CITY PLAN COMMISSION STAFF REPORT

CD-CPC-2026-00070

North Oak Townhomes

Plan Conditions

STREAM BUFFER PLAN
N OAK TOWNHOMES
DEVELOPMENT PLAN/PROJECT
PLAN/PRELIMINARY PLAT
KANSAS CITY, CLAY COUNTY, MO

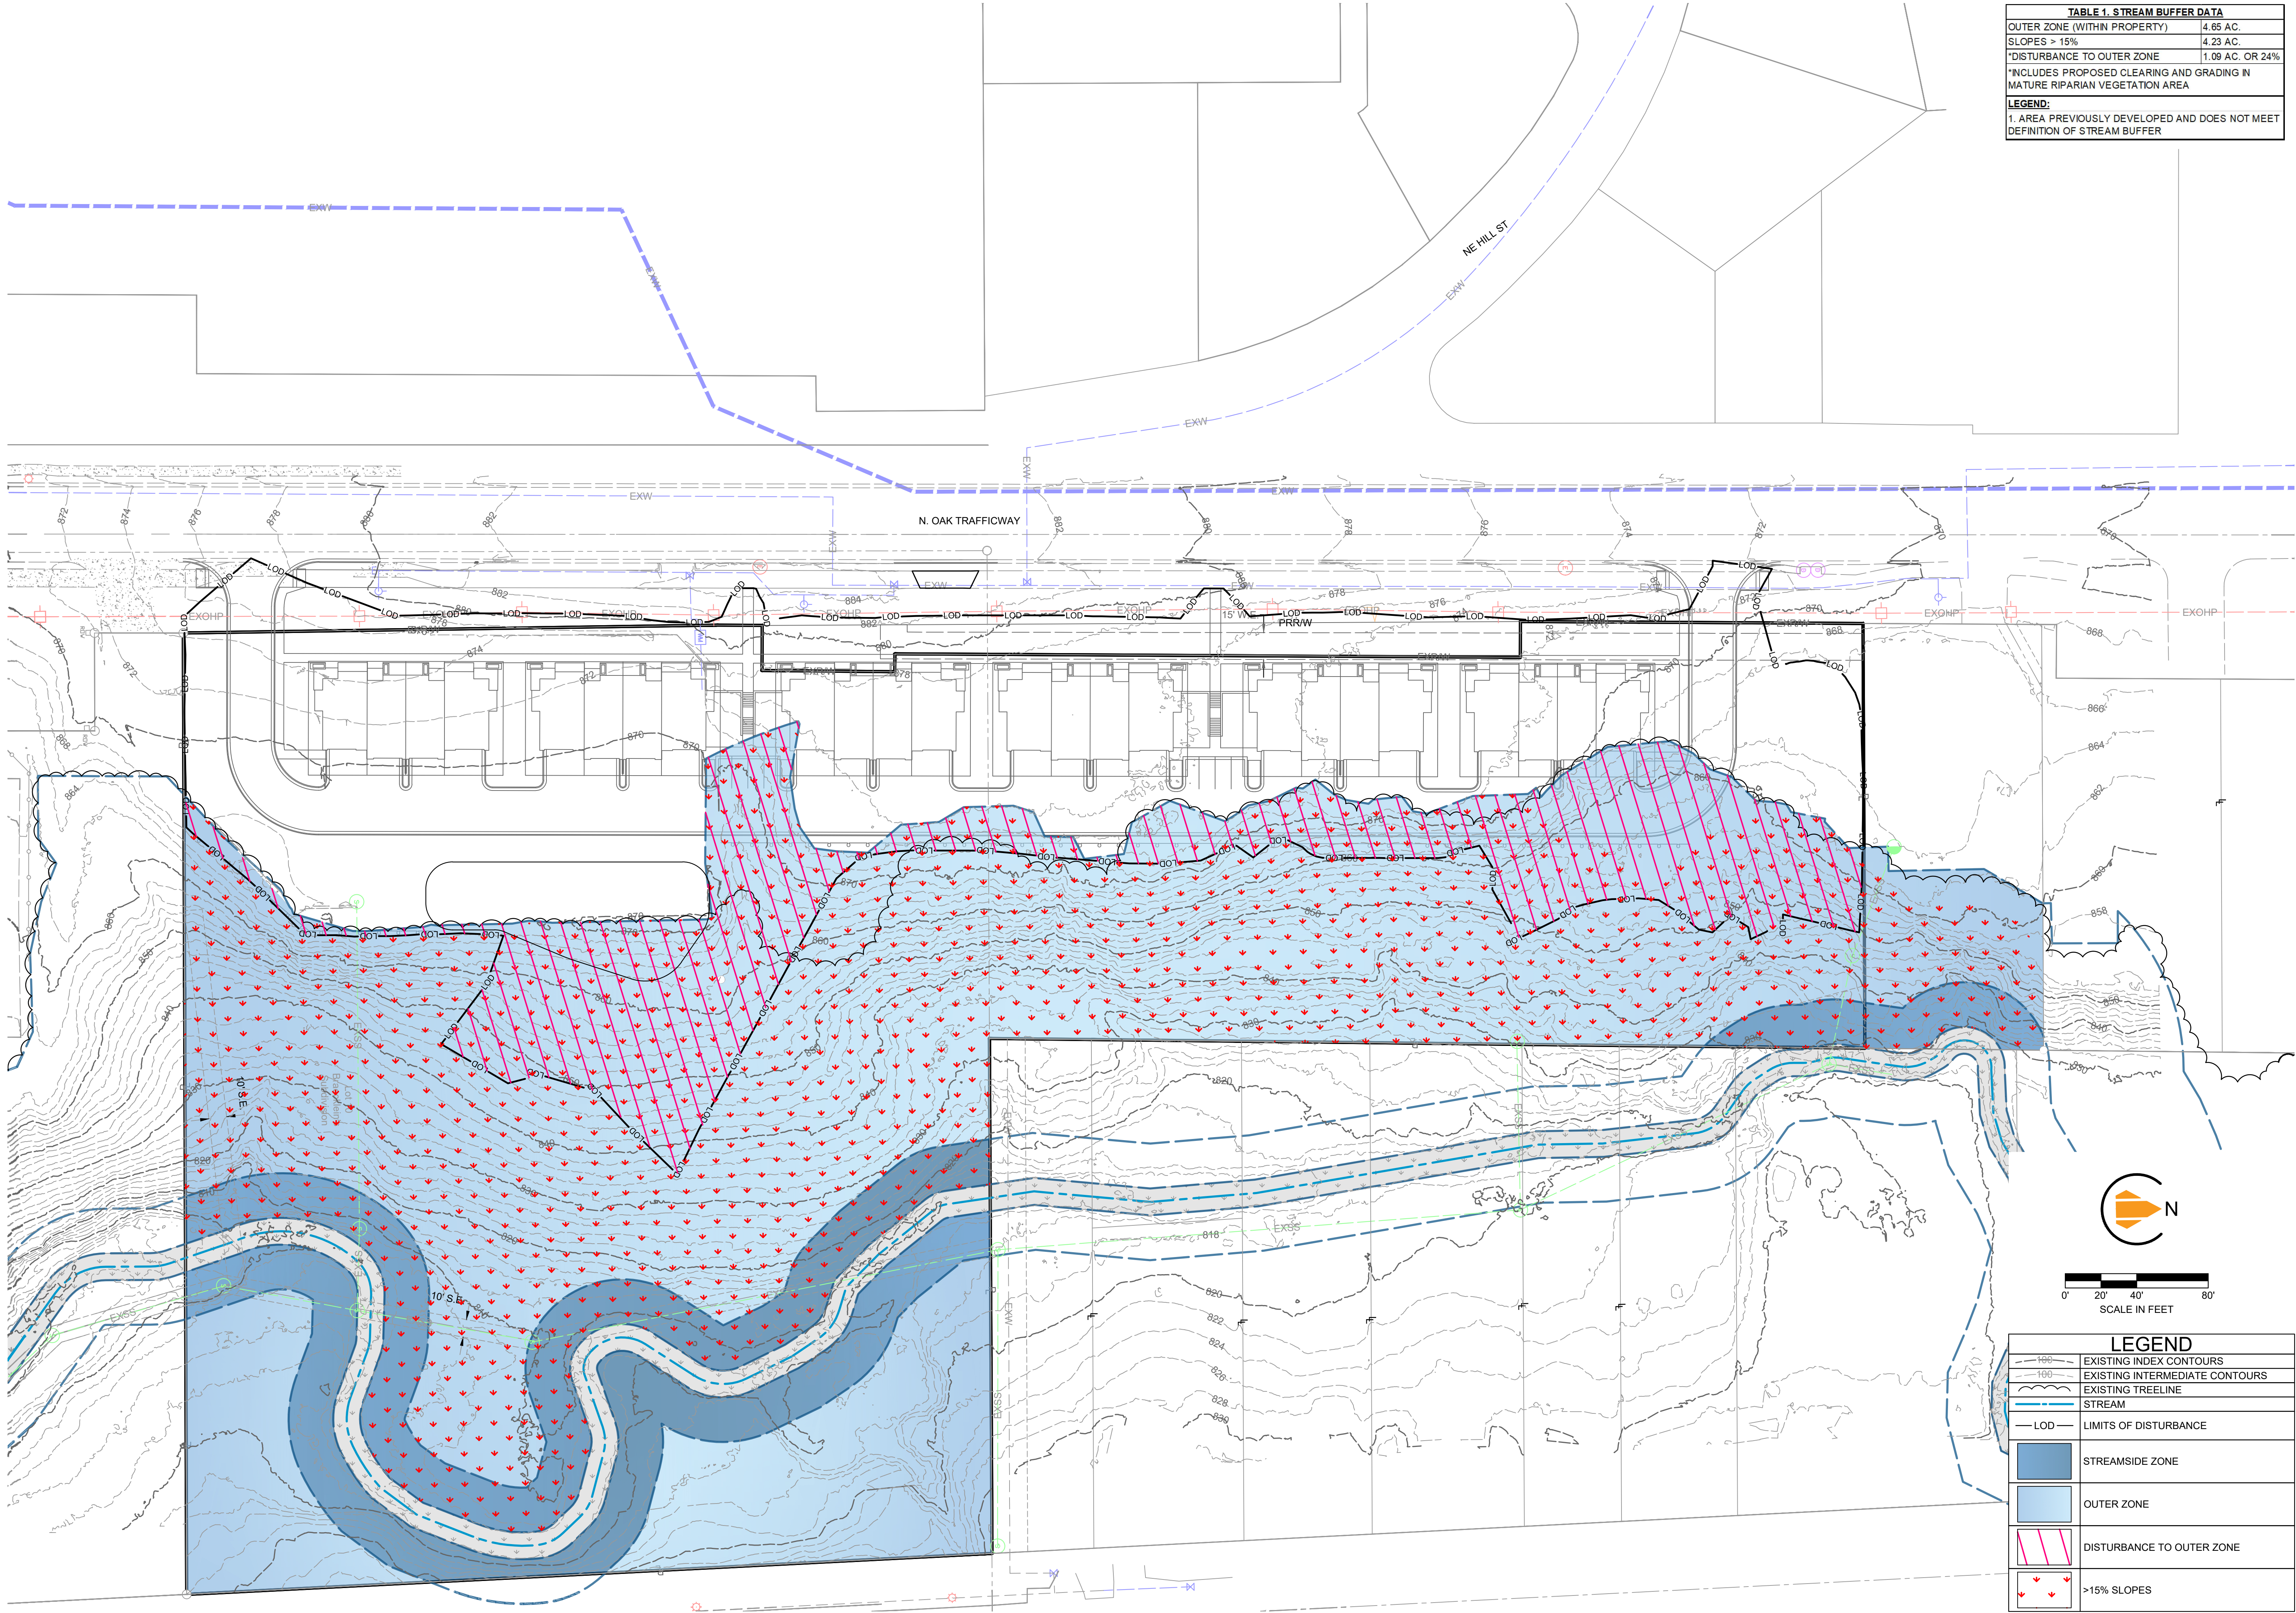
38. The developer shall submit a Preliminary Stream Buffer plan prior to approval of the plan in accordance with the Section 88-415 requirements.
39. The developer shall submit a final stream buffer plan to KC Water for approval prior to issuance of any building permits and obtain permits for the Stream Buffer prior to removal of any mature riparian species within the buffer zones due to construction activities on the site, in accordance with the Section 88-415 requirements.

40. The developer shall grant on City approved forms, a STREAM BUFFER Easement to the City, as required by Chapter 88 and KC Water, prior to issuance of any stream buffer permits.
